**1958 Agreement – Consideration of draft amendments
to existing Regulations submitted by GRSG**

Proposal for Supplement 1 to the 03 series of amendments to Regulation No. 46 (Devices for indirect vision)

Submitted by the Working Party on General Safety Provisions *

Figure 1

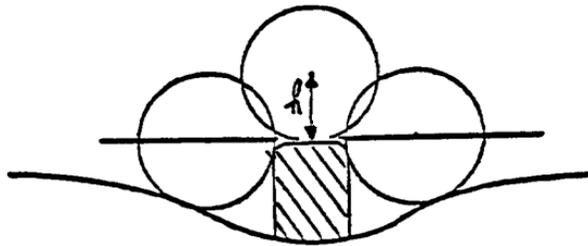
Insert new paragraphs 6.1.1.4. to 6.1.1.4.2., to read (including a new figure 1):

- 6.1.1.4.2. If the dimension of the projection of a component which is mounted on a surface other than convex cannot be determined by simple measurement, it shall be determined by the maximum variation of the distance of the centre of a 100 mm diameter sphere from the nominal line of the panel when the sphere is moved over and is in constant contact with that component. Figure 1 shows an example of the use of this procedure.
